***The Planning Act 2008 - Chapter 2 Examination TR010025  
A303 Amesbury to Berwick Down Improvements***

***Written Submission by the Council for British Archaeology and  
CBA Wessex***

***Summary of Oral Evidence given on 21<sup>st</sup> August 2019***

## ***CBA Summary of Oral Evidence given on 21<sup>st</sup> August 2019***

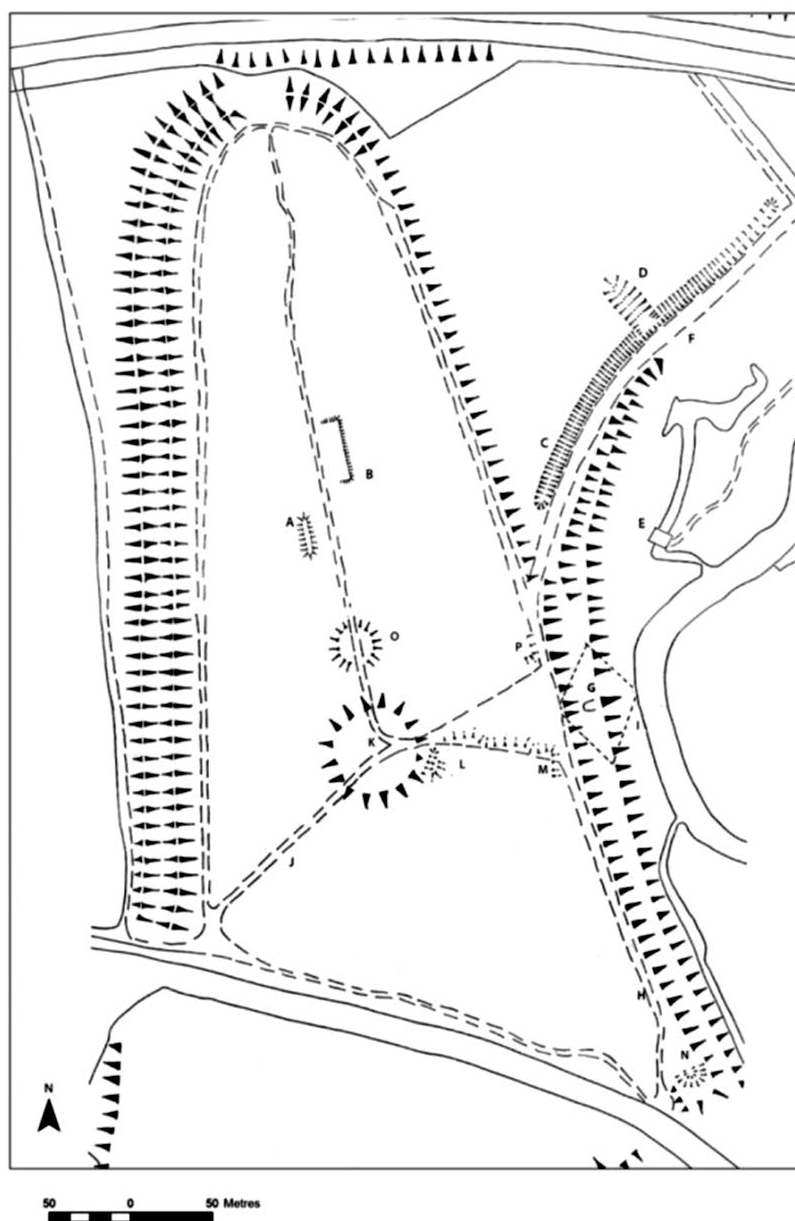
- f) As part of Bridgman's 1738 landscaping scheme, Vespasian's Camp was modified to incorporate carriage drives, walks and new vistas (see detailed plan next page). Bowden (2016, p8) suggests that the N entrance was "widened for the passage of a carriage drive in the 18th century, as there is now an 8m-wide gap between the substantial bank terminals." Before the present A303 cutting through the ridge at this point, the carriage drive would have emerged in a long narrow field leading NW to the King Barrow Ridge monuments, in the area that by 1773 had been incorporated into the parkland (see map showing 19th century landuse in CBA comments on ExA Questions 2 [REP6-084] pp 22). On the map below dated 1823 (Bowden 2016 Fig 3 p.4) a track is shown on this line still

surviving after the area reverted to fields with tree clumps, retaining most of the key features of the designed landscape. This line follows a field boundary severed by the present A303, more being lost to the scheme proposed.
